**Planning Report to the 1 November 2023
Local Planning Panel Meeting**

Item 4.**Development Application: 51-53 Wells Street, Redfern - D/2022/792**

File No.: D/2022/792

Figure 9: Proposed ground floor plan

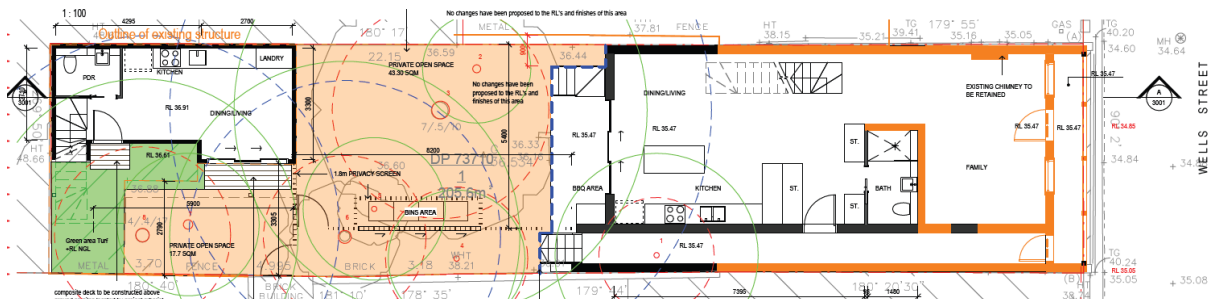
- (a) **The root investigation found a large root from the Jacaranda Tree between the proposed stairs and fence line. However, the plans appear to still require excavation in this area. Updated architectural plans are requested to demonstrate that all existing levels (RLs) will be maintained in this area as identified in the root investigation report.**

- (d) **The architectural drawings must be updated to show all finished floor levels (RLs) on the ground floor plan.**
 - (e) **Specification of the proposed finished surface materials surrounding Tree 8.**

- (f) Additional shadow analysis demonstrating the extent of impact to the windows of adjoining dwellings.
- (g) The bin storage area for the primary dwelling is located in the walkway to the secondary dwelling and leaves less than a meter width for access. The location of the bins must be moved out of the path of travel by shifting the privacy screen to the west, or an alcove made in the privacy screening to store the bins.
- (h) Stormwater drainage plan that shows the proposed drainage arrangements on site including location of gutters etc.

Figure 22: View from the sun mid-winter. Direct sunlight to windows and private open space is shown in green.

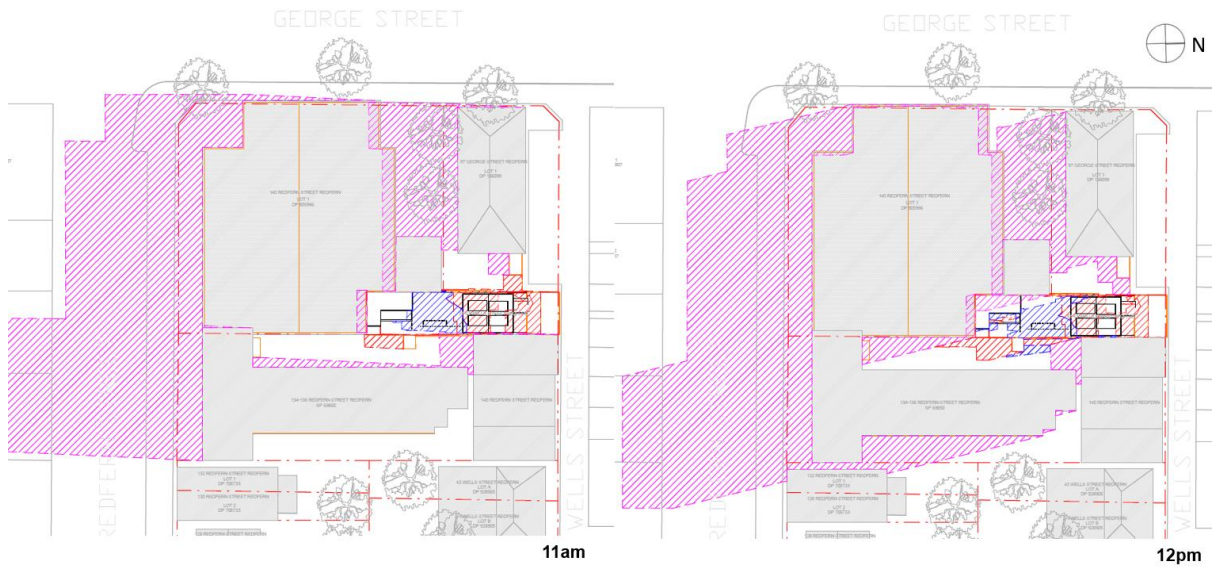
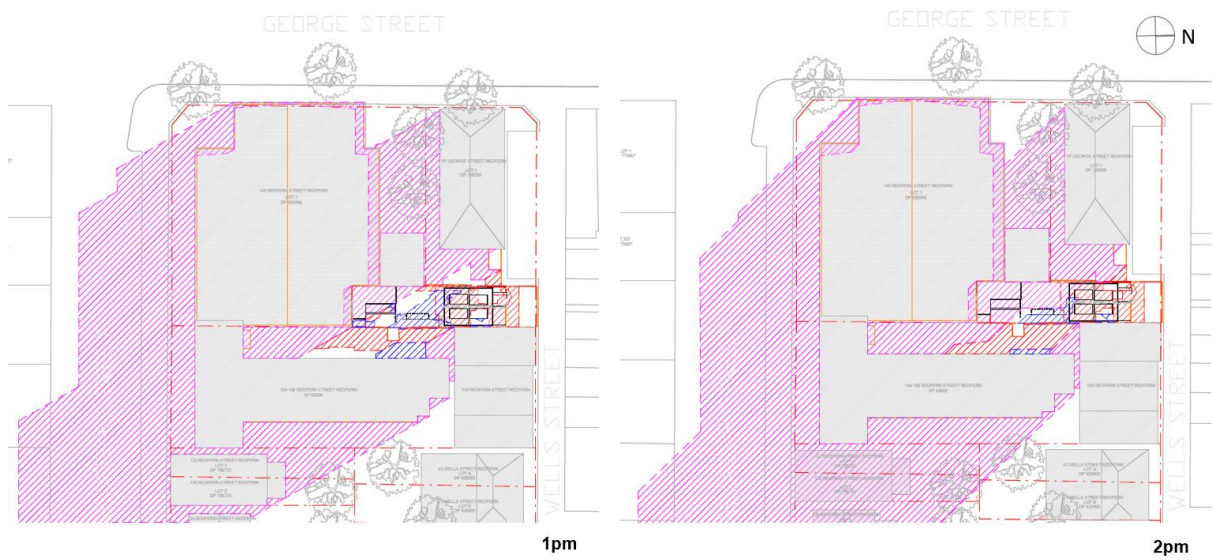
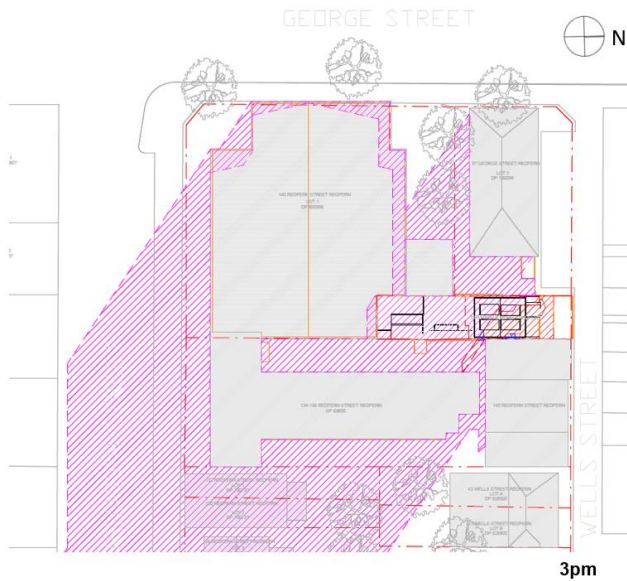
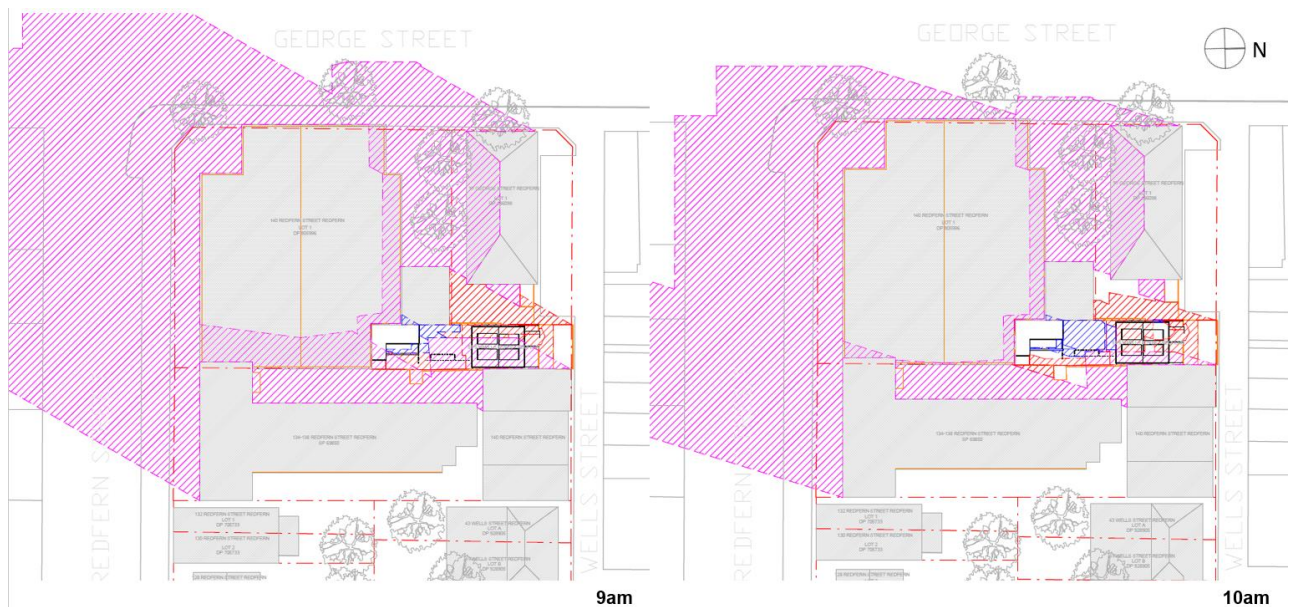
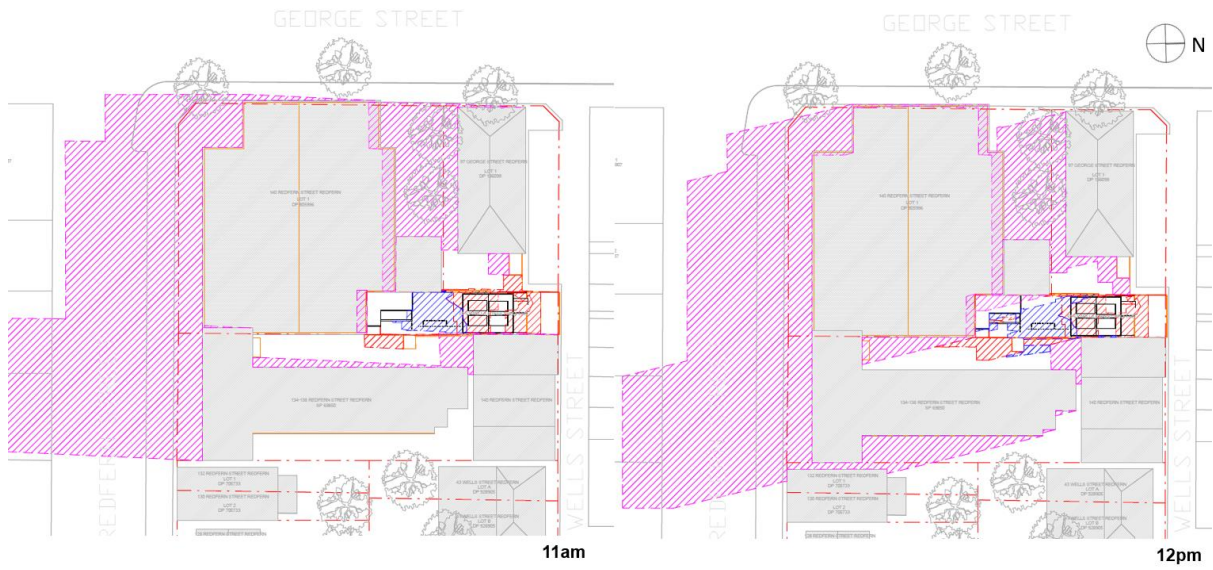
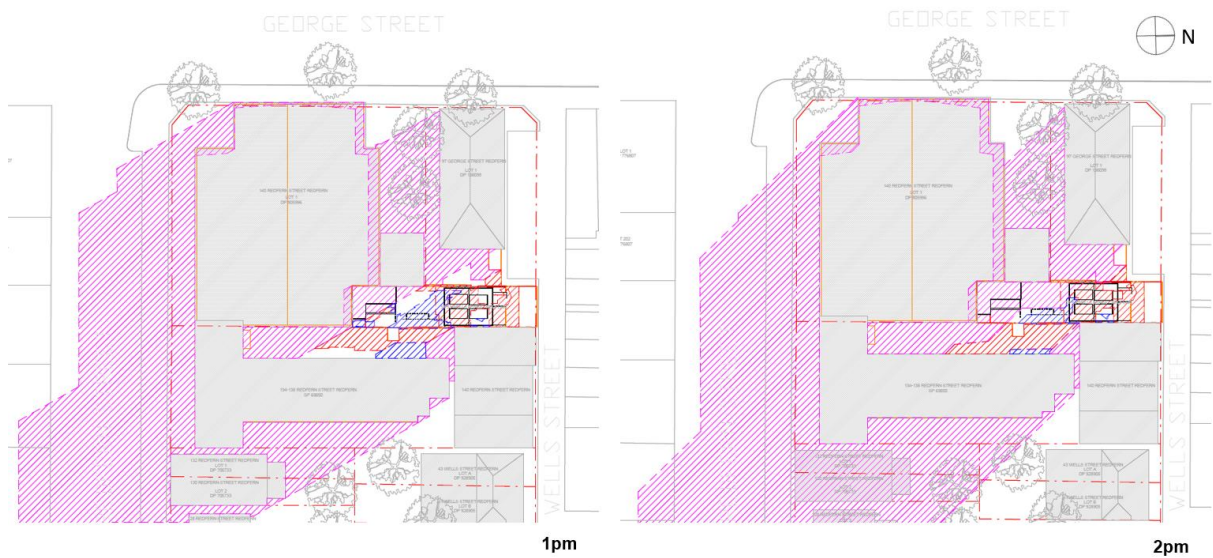
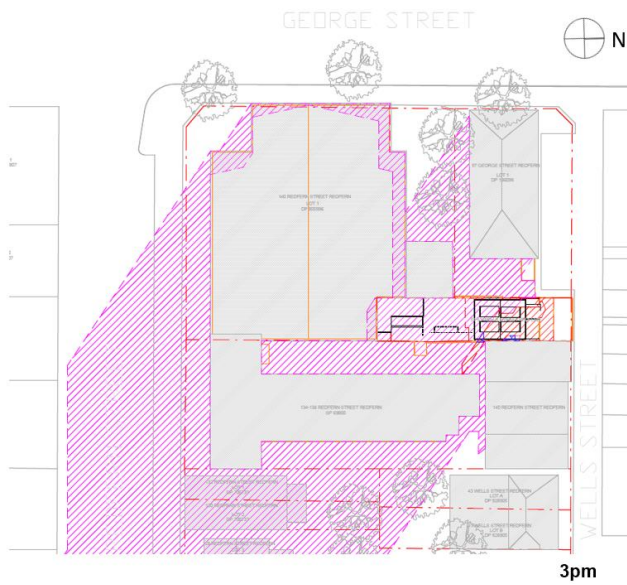
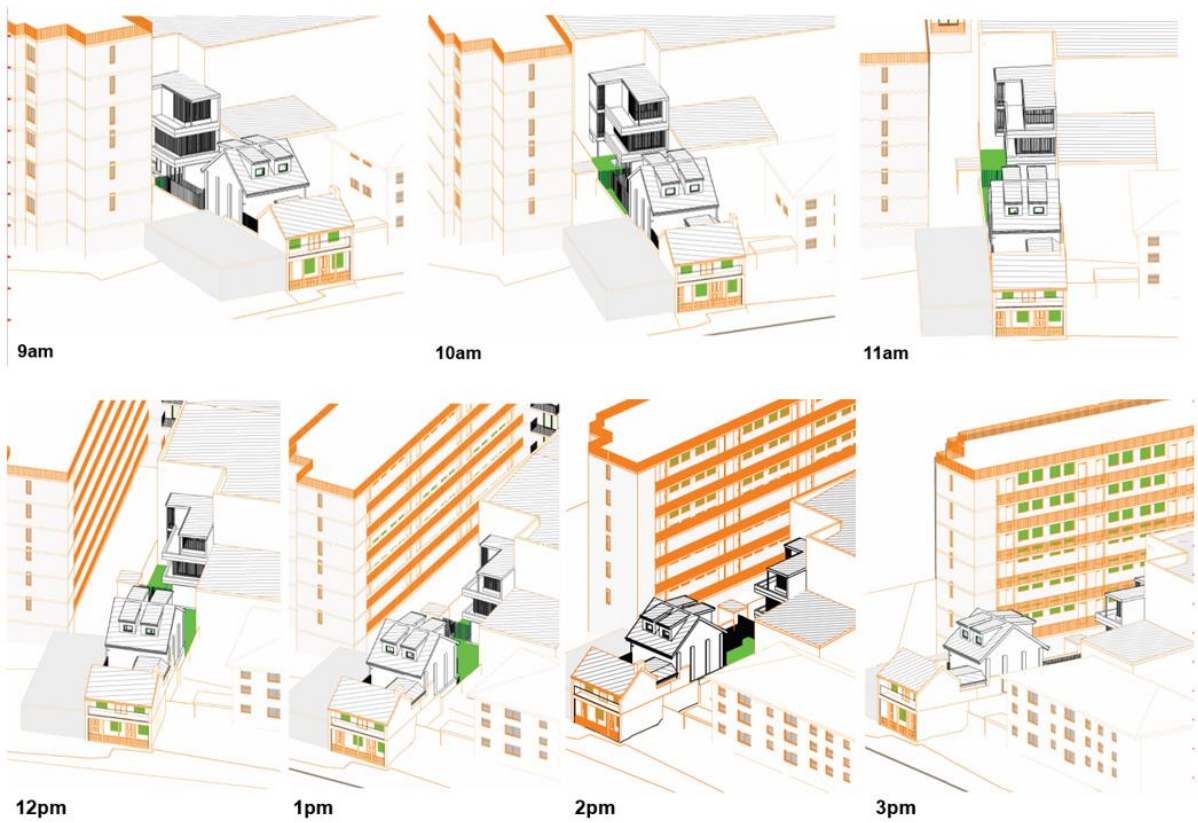
42. The shadow diagrams demonstrate:
 - (a) There is no additional overshadowing as a result of the development between 9am and 1pm.
 - (b) There is some additional overshadowing to the level one apartments between 2pm and 3pm, indicated by the view from the sun diagrams, where some windows disappear behind the proposed new building (see Figure 22 above). However, it is considered acceptable as the private open space (balconies) and living room windows are located along the eastern elevation, which is unaffected by the proposal.

43. Generally, the proposal maintains an acceptable level of solar access to neighbouring developments. Noting that located directly to the south-east of the proposal is the blank wall of 140 Redfern Street, which does not require solar access to be protected. Further, solar access to 97 George Street to the west of the site is unaffected by the proposal.

44. Notwithstanding, the minor additional overshadowing between 2pm and 3pm is acceptable considering that the additional overshadowing is caused by height that is compliant with the 12m 'height of buildings' development standard.
